# METROPOLITAN GOVERNMENT OF NASHVILLE AND DAVIDSON COUNTY

## STAFF RECOMMENDATION

905 B Boscobel Street

**Application:** New construction – primary building

designed by:	-
drawn by:	FDI
checked by:	FDI
date:	07-31-2012
<b>A-6.0b</b>	
EXTERIOR ELEVATION "B"

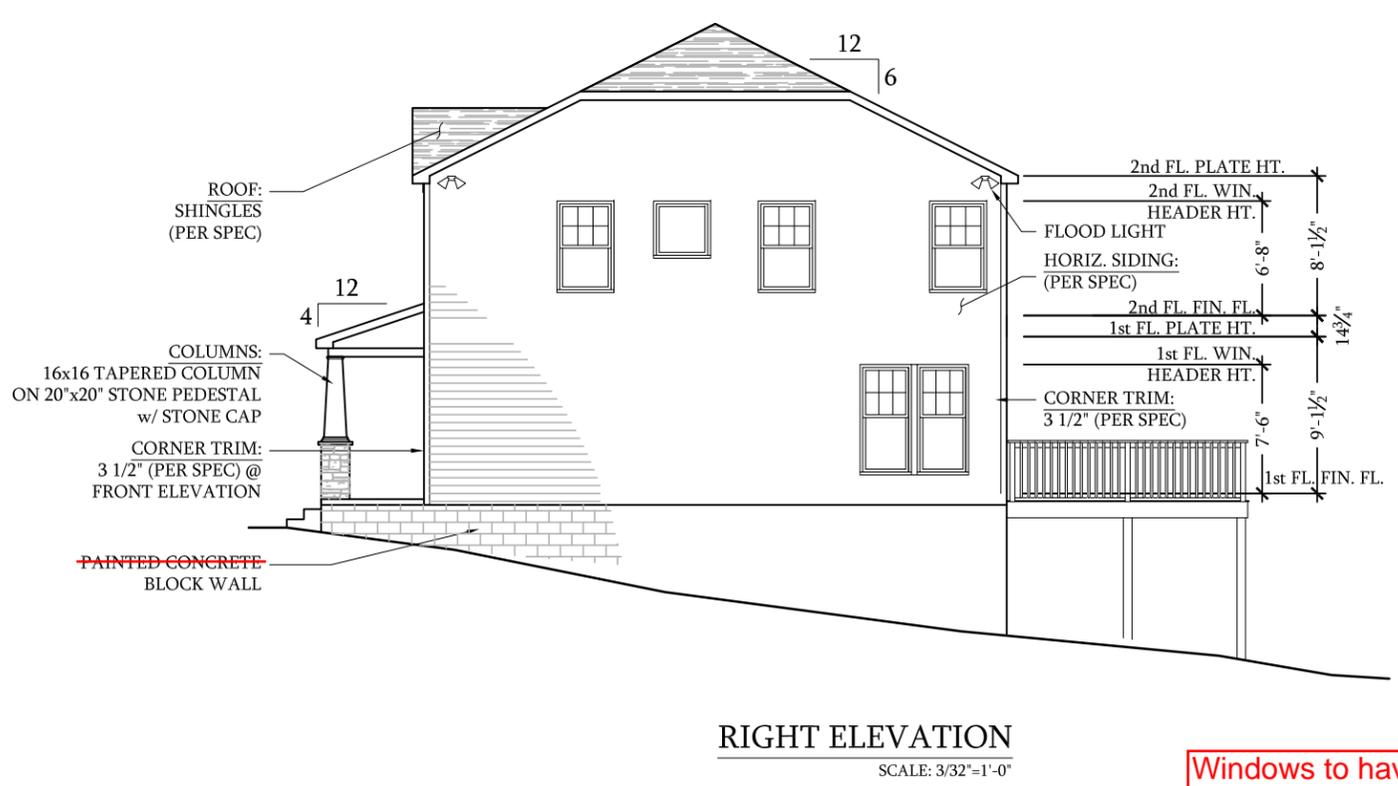
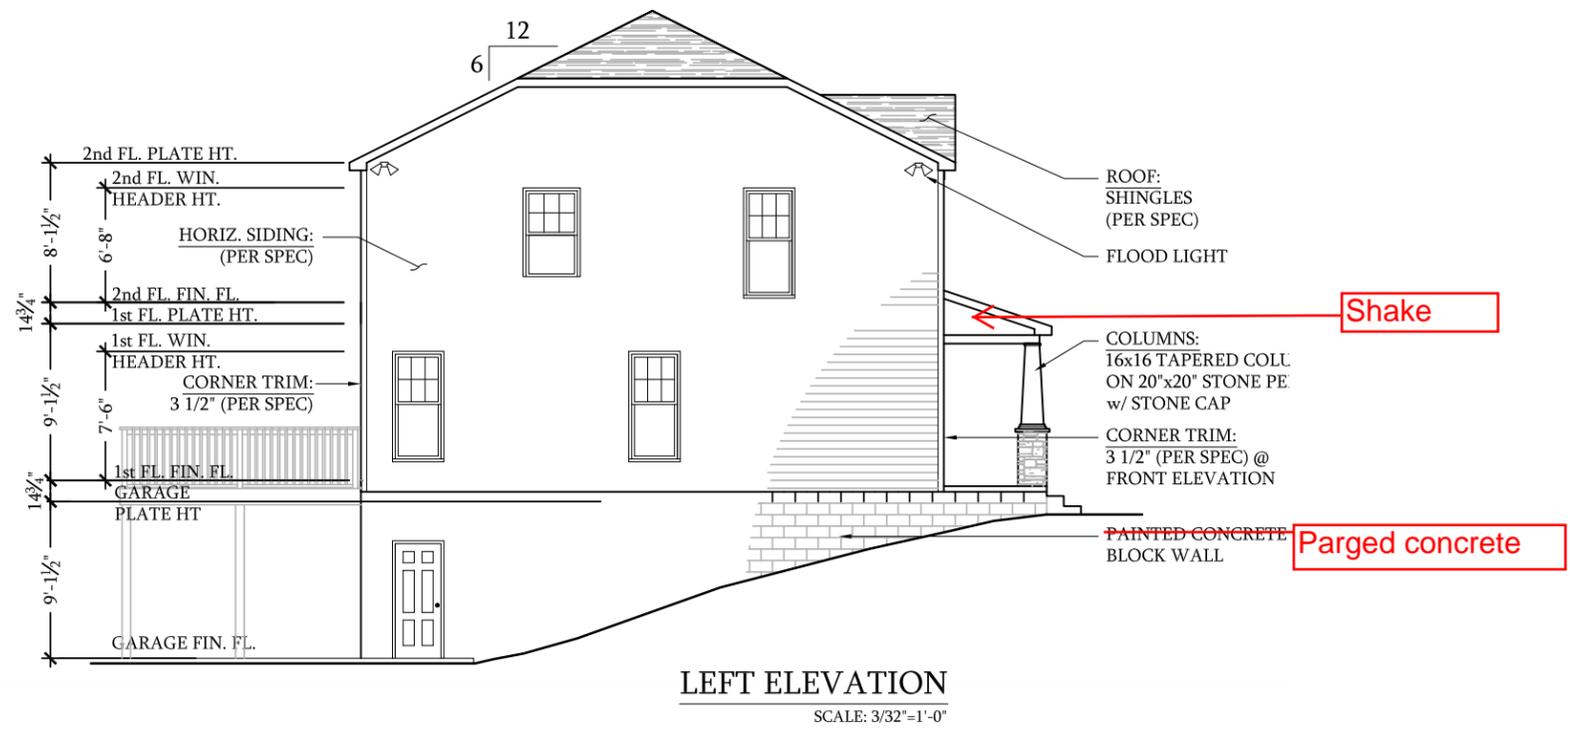
Staff surveyed the area and found that there were many roof forms on historic houses, but none have clipped gables. All of the two-story historic structures were found to have hipped roofs. To be more compatible with surrounding historic houses and meet guideline III.B.2.d., staff recommends that the new building have a hipped roof. This would also help to reduce the perceived massing of the structure. Additionally, the proposed eaves are proposed to project only nine inches, which staff finds to be too shallow in proportion to the overall massing of the roof. Staff recommends extending the eaves to at least eighteen inches (18”).

Fiberglass door to be approved by staff

1. The roof shall be hipped in order to more compatible with surrounding two-story historic houses.
2. Additional windows shall be added to the left and right elevations.
3. Staff shall approve the color of the roof material administratively.
4. Staff shall approve windows prior to purchase.
5. Windows and doors shall have four inch (4” nominal) flat casings.
6. The eaves shall be extended to overhang at least eighteen inches (18”)
7. Staff shall approve stone and any other exterior material not specified in the drawings.
8. Staff shall approve exterior appurtenances, light fixtures, landscape features, fences, and the location of outdoor mechanical units.

**A-6.1b**  
EXTERIOR ELEVATION "B"

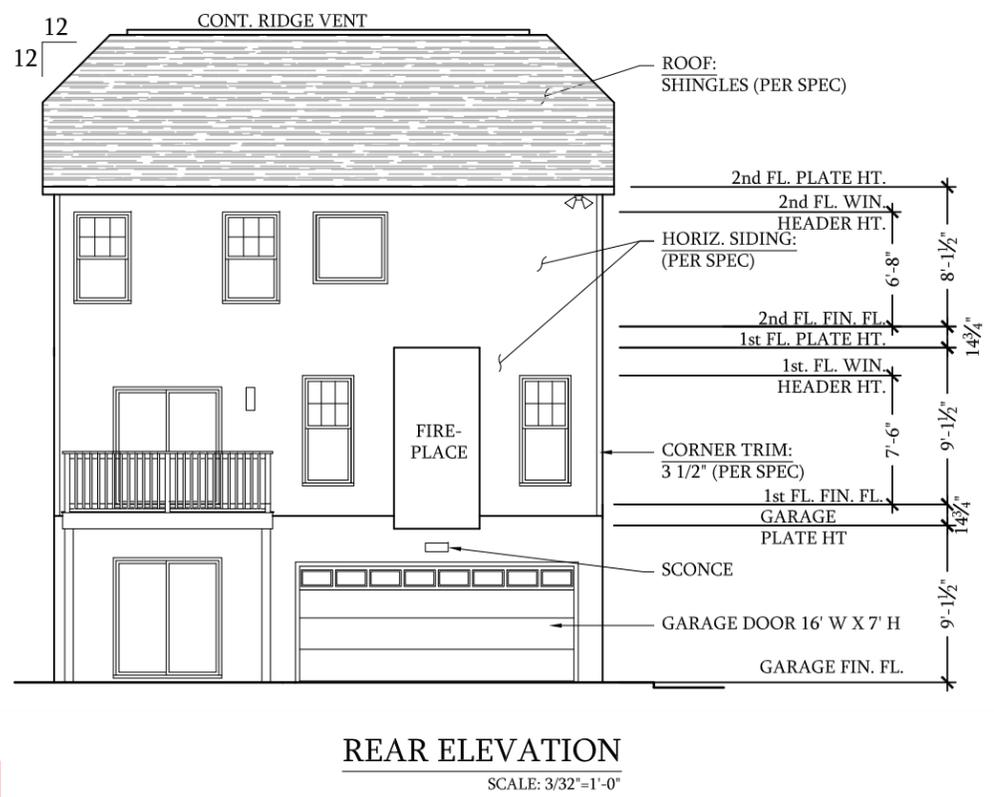
The front façade of the structure will have three evenly spaced bays on each story. This is similar to the window pattern exhibited on many Craftsman style houses nearby. The side facades of the proposed new building would both have large sections of wall-space without any openings. The guidelines require new construction to have a rhythm of solids-to-voids compatible with surrounding historic houses, which typically have a window or door at every ten to twelve feet (10'-12'). Staff recommends that one additional window be added to the left elevation and two on the right in order to meet guideline III.B.2.f.
